**SUBJECT: 15967 PA Block Replacement Kit**

# PARTS & INSTALLATION INSTRUCTIONS

## 15967 P.A. Block Kit E-47/E-57/E-58/E-60/E-61/E-78

**E-47 & E-57**

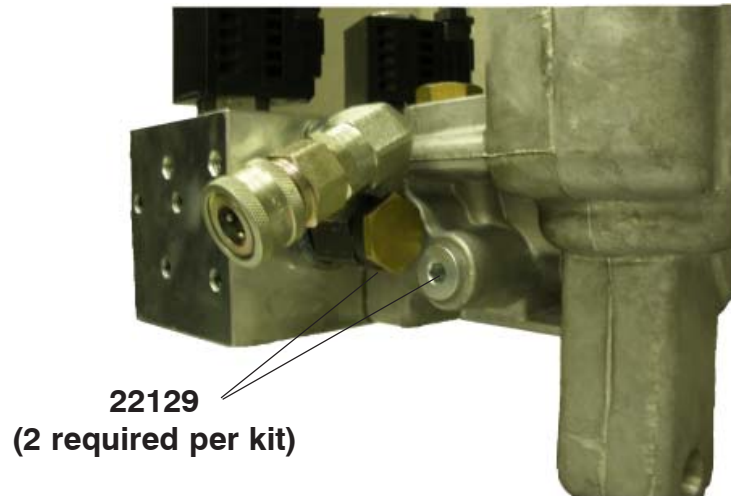
We have changed the PA Block used in the 15967 PA Block replacement kit. This new PA Block can replace existing PA Block's on the E-47/E-57/E-58H/E-60/E-61 Hydraulic Units. In order to replace an E-60/E-61 PA Block it is necessary to remove the lower adjustment and lower filter hex plugs and replace them with a 22129 Allen head plug (see below). We have updated our inventory of 15967 PA Block Kits with (2) 22129 Allen head plugs. Please contact our Customer Service Department to order these at no charge and reference this Service Bulletin. When replacing the PA Block on a E-47 or E-57 the "A" port base collar will need to be cut off (see below).

**Cut off "A" port base collar to allow clearance for the crossover relief valve on the PA Block.**

**E-60, E-60H, E-61 & E-61H Only**

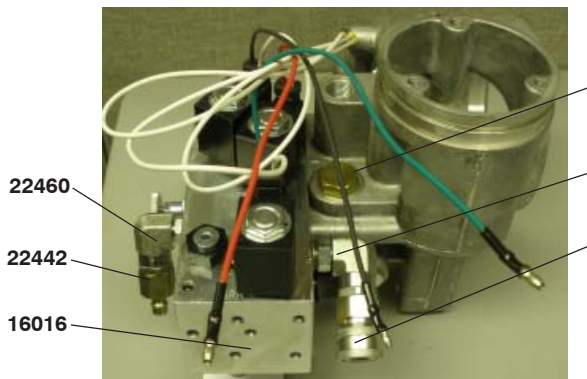
Note: On the E-60/61 units only remove the lower adjustment and lower filter hex plugs and replace with 22129 Allen Plug to allow clearance for the crossover relief valve on the PA Block.
